# SERVICE BULLETIN

Classification: AN15-020A	Reference: NTB15-098A	Date: March 23, 2021
------------------------------	--------------------------	-------------------------

## 2015 MURANO; WITH NON-NAVIGATION SYSTEM AUDIO UNIT (WITH DISPLAY) AND AC SWITCH ASSEMBLY SERVICE INFORMATION

TP150310

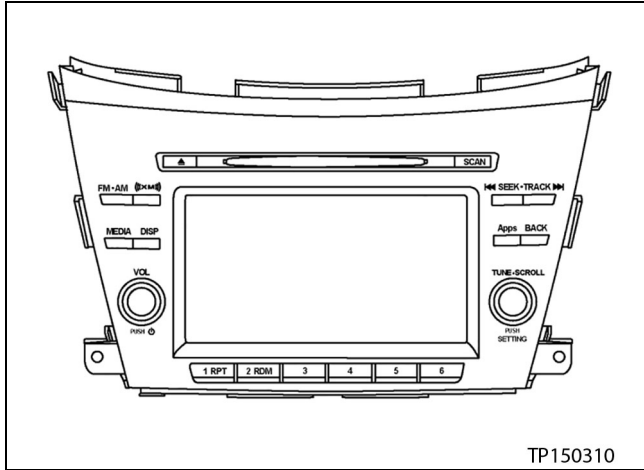
Whenever an A/C switch assembly on an applied vehicle is replaced for any reason, check the P/N of the audio unit.

- If the P/N ends with “**0A**” or “**4A**” (for example, 28185-5AA**0A**), also replace the audio unit.
- If the P/N does NOT end with “**0A**” or “**4A**”, do NOT replace the audio unit.

Location of audio unit P/N

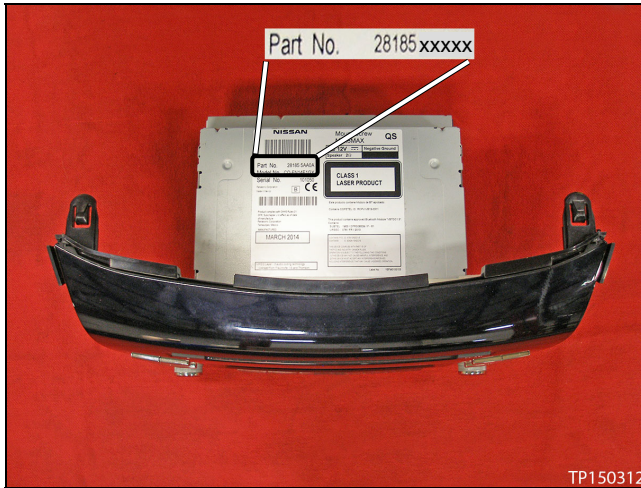
**NOTE:** The audio unit P/N can be checked by the following:

- By removing the audio unit (see page 2)
- Access Service COMM for previous warranty repairs that included audio unit replacement (it would list the replacement P/N)

Location of A/C switch assembly P/N

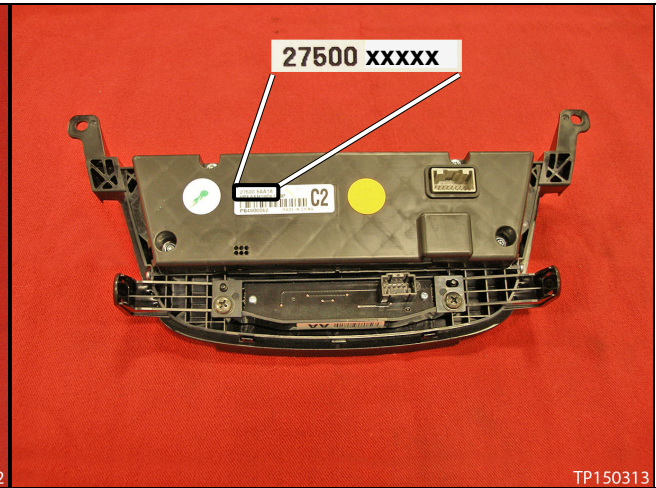
Whenever an audio unit on an applied vehicle is replaced for any reason, check the part number (P/N) of the A/C switch assembly (A/C Controller Assembly).

- If the P/N ends with “**A**” or “**B**” (for example, 27500-5AA1**A**), also replace the A/C switch assembly with part number 27500-5AA1C.
- If the P/N does NOT end with “**A**” or “**B**”, do NOT replace the A/C switch assembly.
